Appendix 2- 21 Cherryfields

Re. 20/00846/HHFUL Installation of external wall insulation, mosaic tile at first floor level to the front and rear, and installation of 3no. AC units, and associated alterations (Retrospective) | 21 Cherryfields Orton Waterville Peterborough PE2 5XD.

15

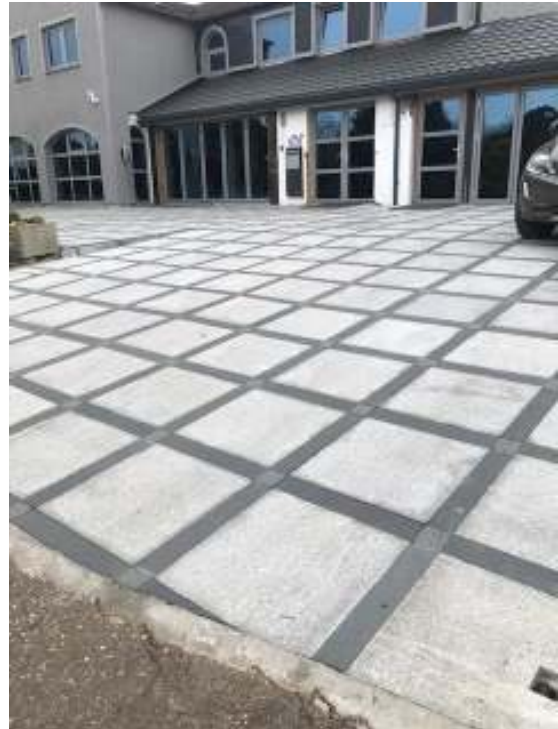
Pic 15 Shows the drive, fully tiled in non permeable material, no drainage visible for any surface water, Again no regard for impact to neighbours, environment or planning department
